Figure 128-1
General Location of Seawater Intakes and Discharges - SRS

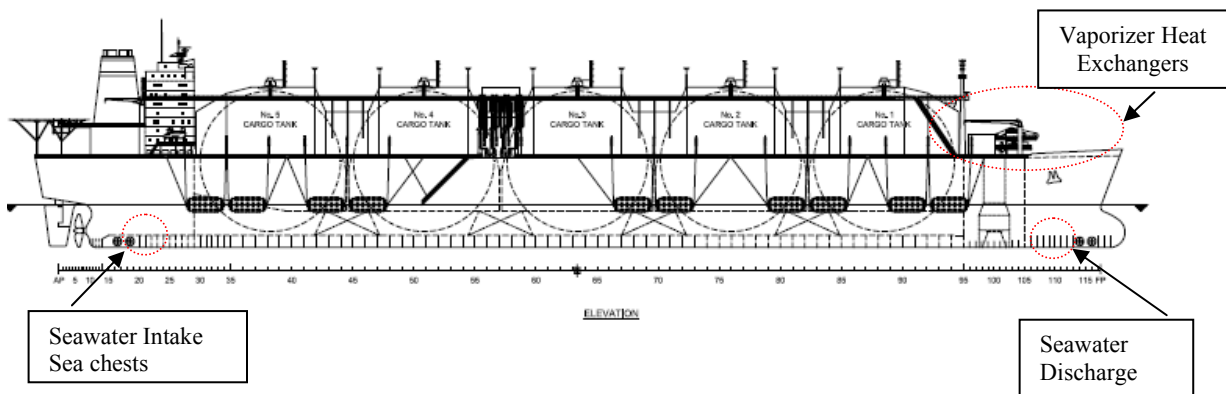
To fully evaluate the use of an open-loop LNG vaporization system as an alternative, assume that both the TRVs and the SRS would use an open-loop vaporization system. To present and assess the potential impacts of a shell-and-tube (open-loop) LNG vaporization system alternative, please provide the following information:

- 1. A general description of how the SRS and TRV would be configured for an open-loop LNG vaporization system. Include a discussion of seawater intake and discharge systems (diffusers, if necessary), as well as the intake and discharge characteristics (temperature, velocity, daily volume); and*
- 2. Discuss the potential impacts on resources that would be affected by an open-loop LNG vaporization system, including but not limited to water quality (including thermal impacts), biological resources (including entrainment and impingement effects), and air quality. Use of existing analyses from published documents (e.g. Gulf Gateway – Docket # 14294), where appropriate, would be acceptable to the USCG.*
- 3. To quantify the thermal impacts, please use the CORMIX computer model simulation to assess the open-loop water discharge from a TRV and the SRS.*

Utilizing open-loop technology, the SRS at the *Calypso* deepwater port would pump seawater from fixed intakes on the vessel's hull below the waterline. The warm seawater would be passed through the vaporizer heat exchangers to provide the heat necessary to change the LNG into its natural gas phase.

Seawater is drawn in through the SRS's sea chests near the stern of the vessel. Seawater is pumped from the vessel's engine room, to the LNG vaporizers at the forward part of the vessel and then led overboard. The total seawater intake for a send-out of 1.5 bcfd would be 36,000 cubic meters per hour (m³/h) or 228 million gallons per day (mgd).

This seawater is used as a heat source and is passed through one side of the vaporizing heat exchanger. LNG is fed to the other side of the exchanger where the heat required for vaporization is transferred. The temperature of the seawater is lowered in this process by approximately 13 degrees Fahrenheit (°F; 7.2 degrees Celsius [°C]), and this cooler water is discharged near the bow of the SRS. The boilers would not be required for an open-loop vaporization system.

Dimensions of the inlet sea chest boxes and their associated strainer grids will be sized to ensure that water velocity through the strainers will not exceed 0.49 feet per second (ft/s).

The discharge of cooled seawater from open loop operations would result in two plumes of water approximately 13°F (7.2°C) cooler than the ambient water. Each discharge would produce up to 114 mgd.

Figure 129-1. STL Suction Anchor for TRV

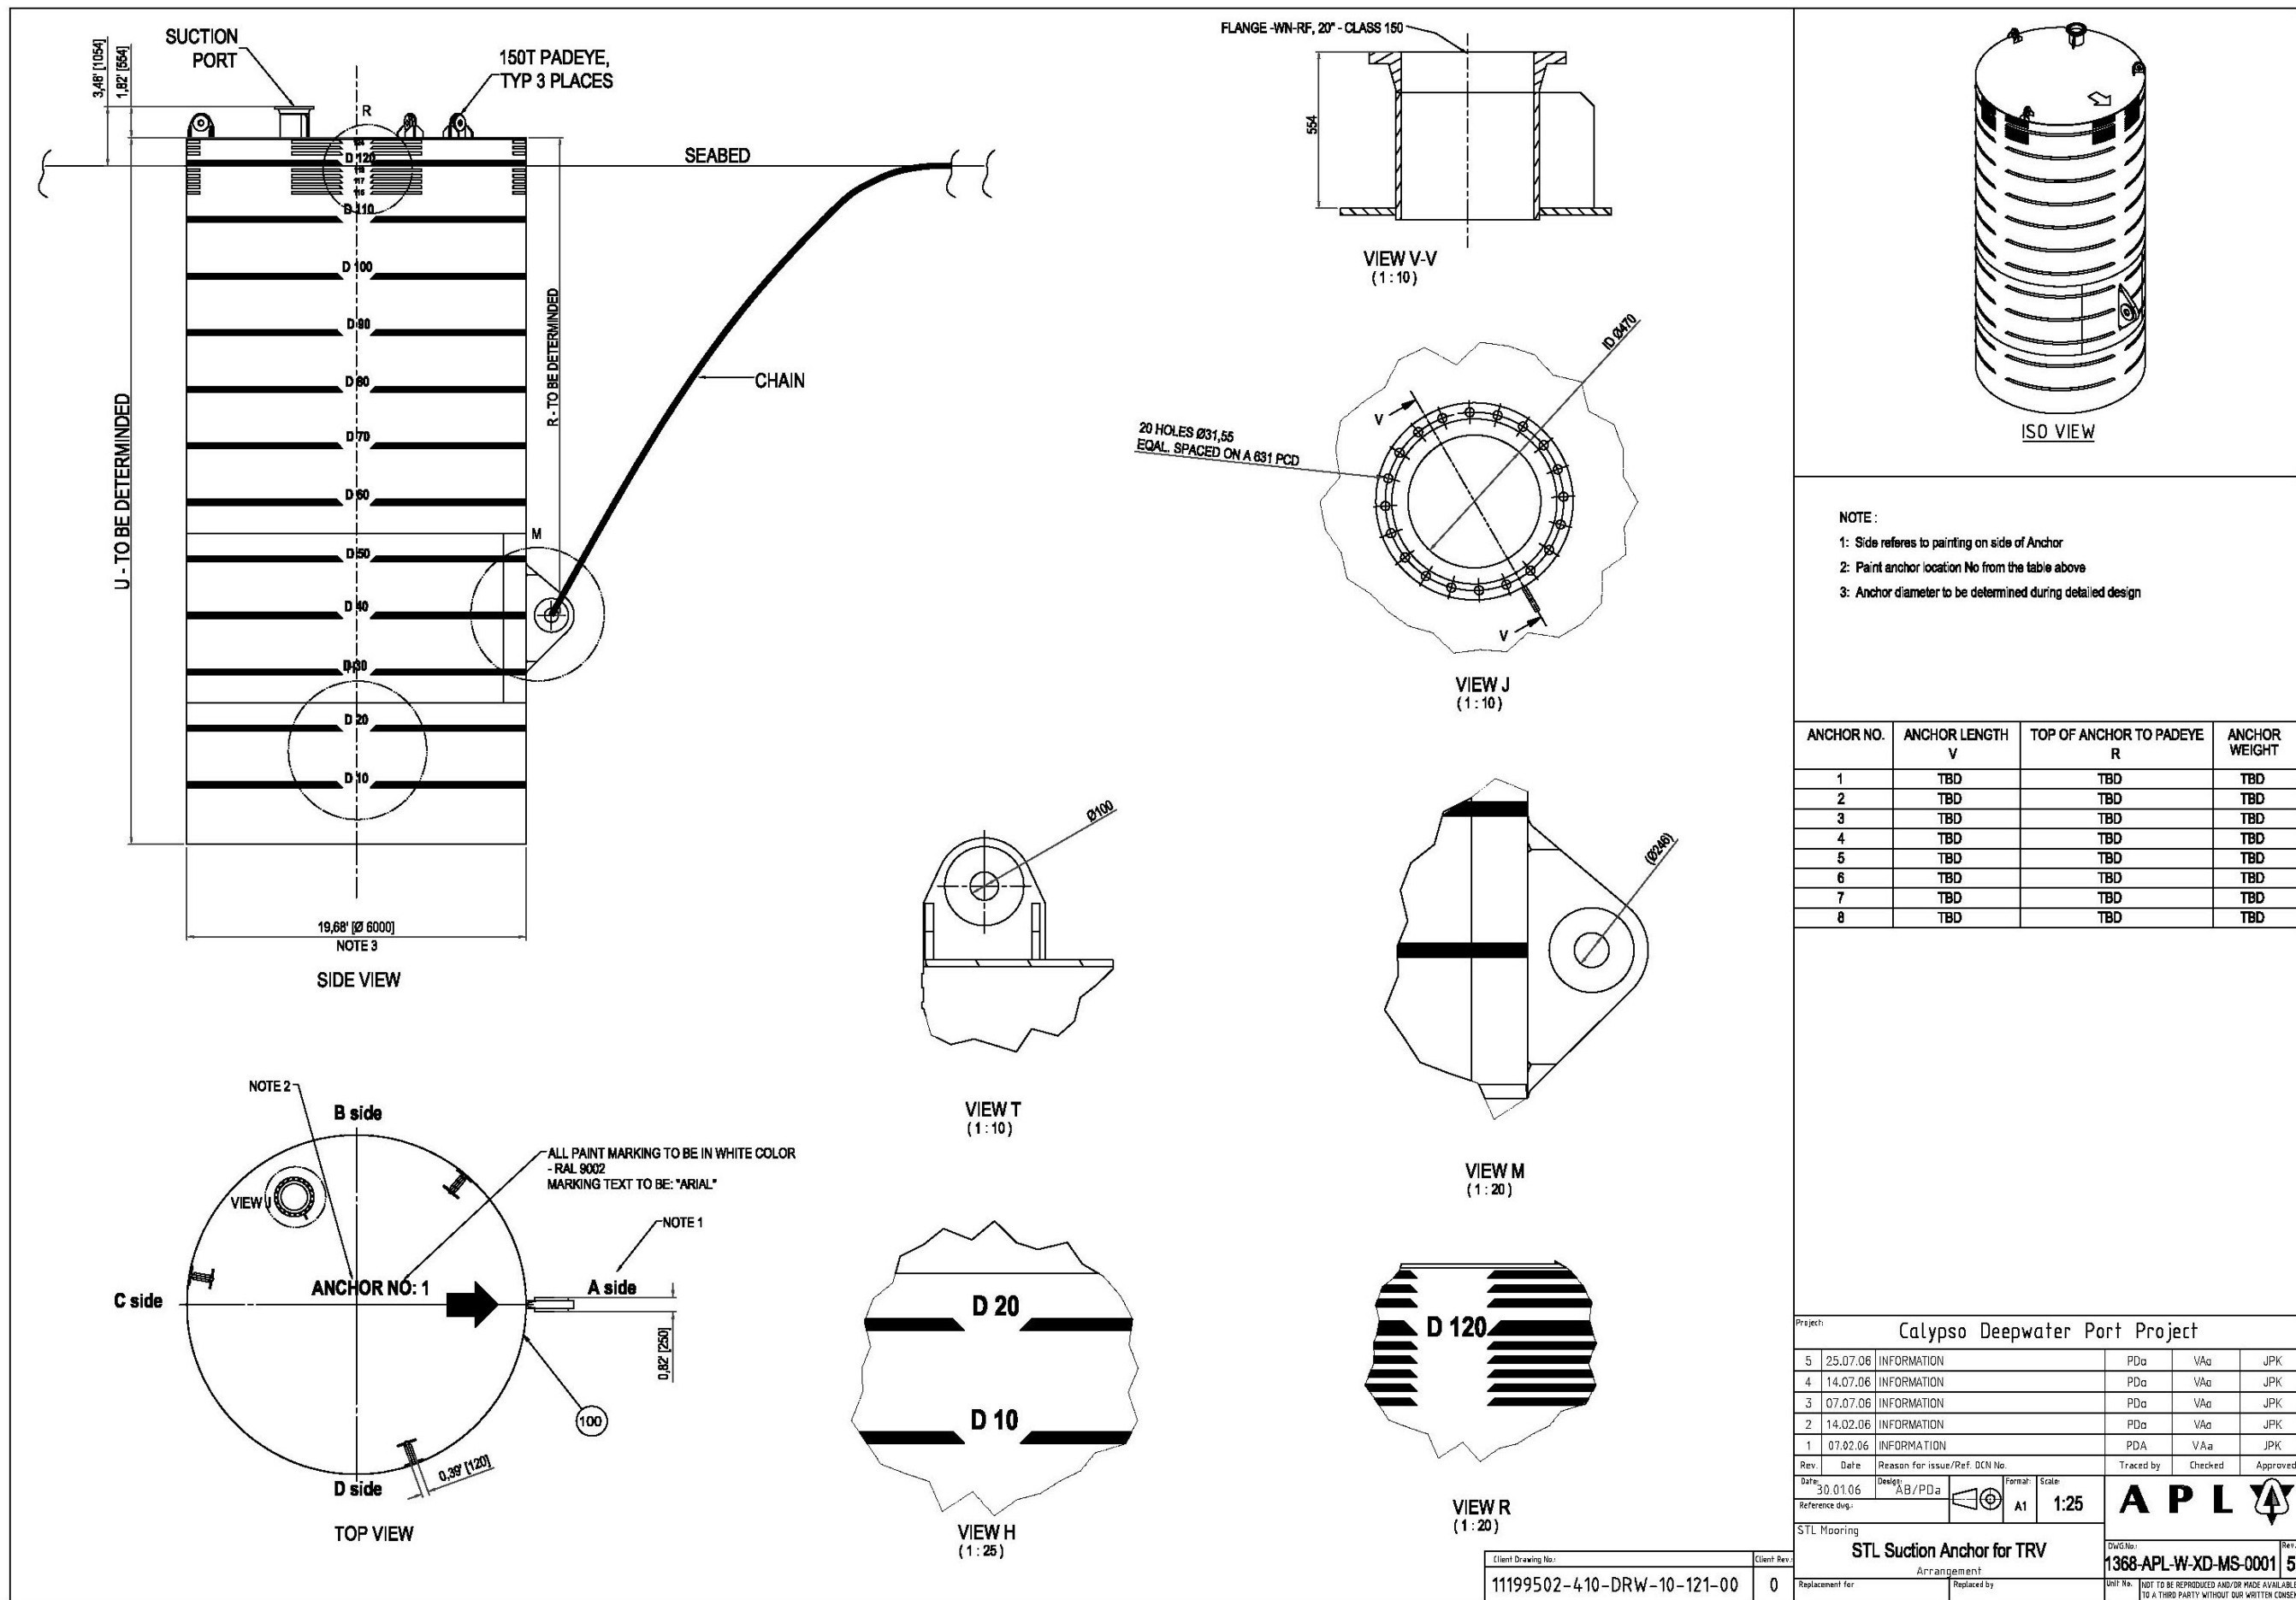
What is the height of the suction pile that would protrude above the sea floor be provided in the EIS. Appendix I, Mooring Documents and Drawings indicates that the suction piles would protrude up to 3.5 feet above the sea floor. Please confirm that this value is correct.

During installation of suction anchors, the final position will depend on the soil heave inside the anchors. The numbers given on the attached drawing (about 1.0 meter or 3.5 feet) are representative of protrusion normally experienced.
